**SUBJECT: NEW VEHICLE DEMONSTRATION / DELIVERY HOLD  
 Customer Satisfaction Program 20B34 – Supplement #1**  
 Certain 2020 Model Year Explorer Vehicles Equipped with 2.3L Ecoboost Engine  
 Transmission Oil Cooler

**NEW VEHICLE DEMONSTRATION / DELIVERY HOLD**  
**Customer Satisfaction Program 20B34 – Supplement #1**  
Certain 2020 Model Year Explorer Vehicles Equipped with 2.3L Ecoboost Engine  
Transmission Oil Cooler

## CERTAIN 2020 MODEL YEAR EXPLORER VEHICLES — TRANSMISSION OIL COOLER REPLACEMENT

**FIGURE 1**

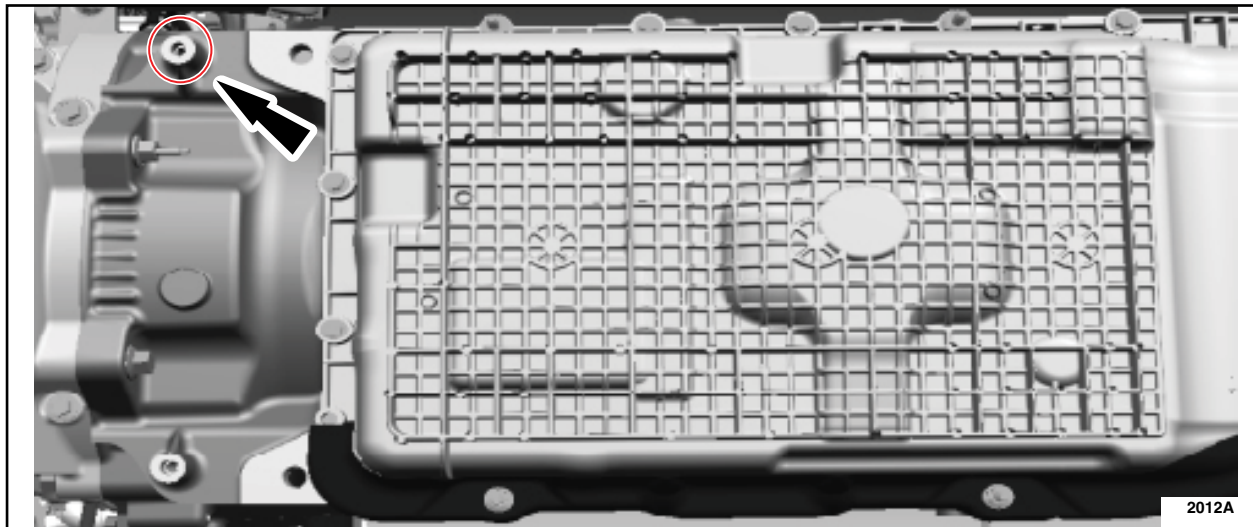
1. Replace the transmission fluid cooler. Refer to Workshop Manual (WSM), Section 307-02.
2. Install the M8x30 bolt. Torque to 25 Nm (18 lb-ft). See Figure 1.
